ISSUE: Permit to Demolish/Capsulate (partial) and Certificate of Appropriateness for addition and alterations

LOCATION: Old and Historic Alexandria District
820 South Lee Street

BAR#2023-00538 & BAR#2023-00539
820 S Lee Street

The applicant requests a Permit to Demolish/Capsulate (partial) and Certificate of Appropriateness to add a third story and a rear first-floor open deck, as well as alterations, at 820 South Lee Street.

Figure 1: 818 - 824 S. Lee with 820 proposed elevation second from left

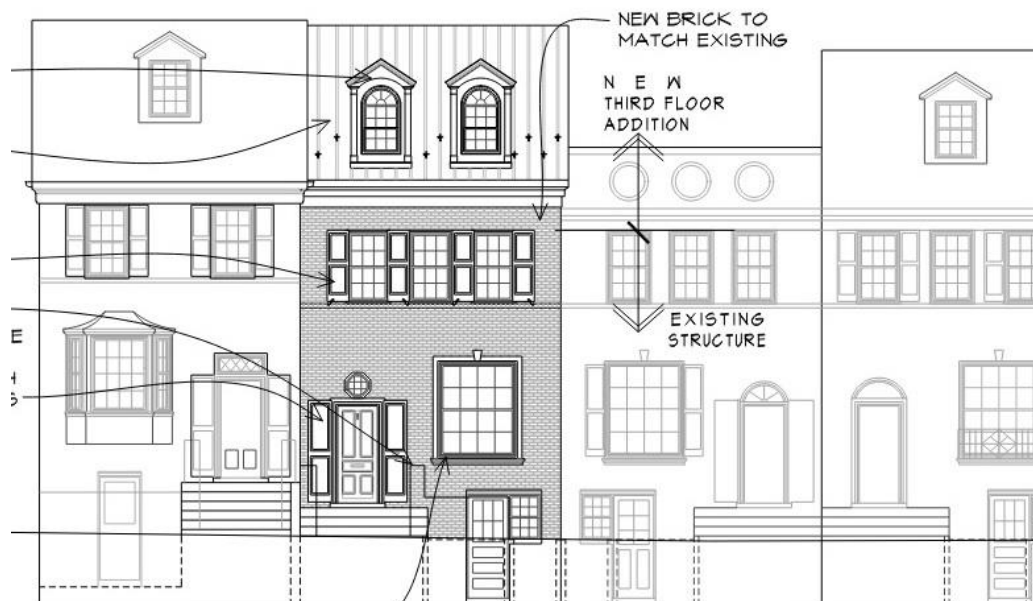
The *Design Guidelines* encourage “respectful additions” which “make use of the design vocabulary of the existing...structure” and supports additions that “are compatible with both the architectural character of the existing house and the immediate neighborhood.” Staff finds that the proposed Colonial Revival addition fully complies with these guidelines. Figure 1 depicts the proposed addition to 820 South Lee in the context of its blockface. The subject property will be no taller than 818 South Lee immediately to the north and will harmonize with 822 and 824 to the south. Much like other houses on the block, the proposed third story will have gable dormer windows.

The standing seam metal roof will improve the appearance of the primary elevation, as will the new operable paneled shutters with shutter dogs. Staff also finds that limewashing or staining the exterior brick would be appropriate for this 1950s building. It will not harm the brick and could

improve the house's appearance, as the brick is an unusual color with some areas of discoloration. The new Pella Architect Series aluminum-clad windows are appropriate and could be administratively approved.

Figure 2: proposed rear addition

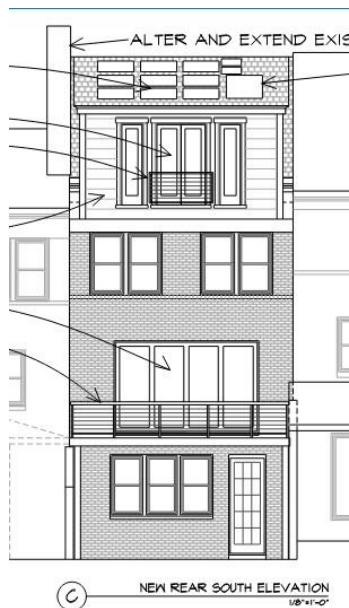
As for the rear/east elevation, this will be barely visible from Jones Point Park due to the numerous trees here. Compared to other rear additions in this block, the proposed alterations are minimal. See Figure 2 for the proposed alterations to 820 South Lee and Figure 3 for the rear elevations of 800 – 814 South Lee.

The rear/east shed roof portion of the addition will have an asphalt shingle roof with solar panels. The sides of this addition will be cementitious siding and the chimney will be expanded. New doors will be wood clad and the Juliet balcony at the third story and the open deck at the first story will both have metal railings. These alterations and materials also comply with the *Design Guidelines* and will be minimally visible from a public right of way.

The *Design Guidelines* state that open decks “are primarily a late-20th century occurrence... and are suburban in character.” The Board has previously approved the construction of open decks in sections of the districts with a distinctly suburban feel or where there is minimal visibility of the deck from a public way. The subject property meets both these criteria. These 1950s townhouses are in a part of Alexandria with a distinct suburban feel. As noted above, it will be minimally visible and the wall area and window to be removed in order to construct the deck are not of unusual or uncommon design and could be reproduced easily.
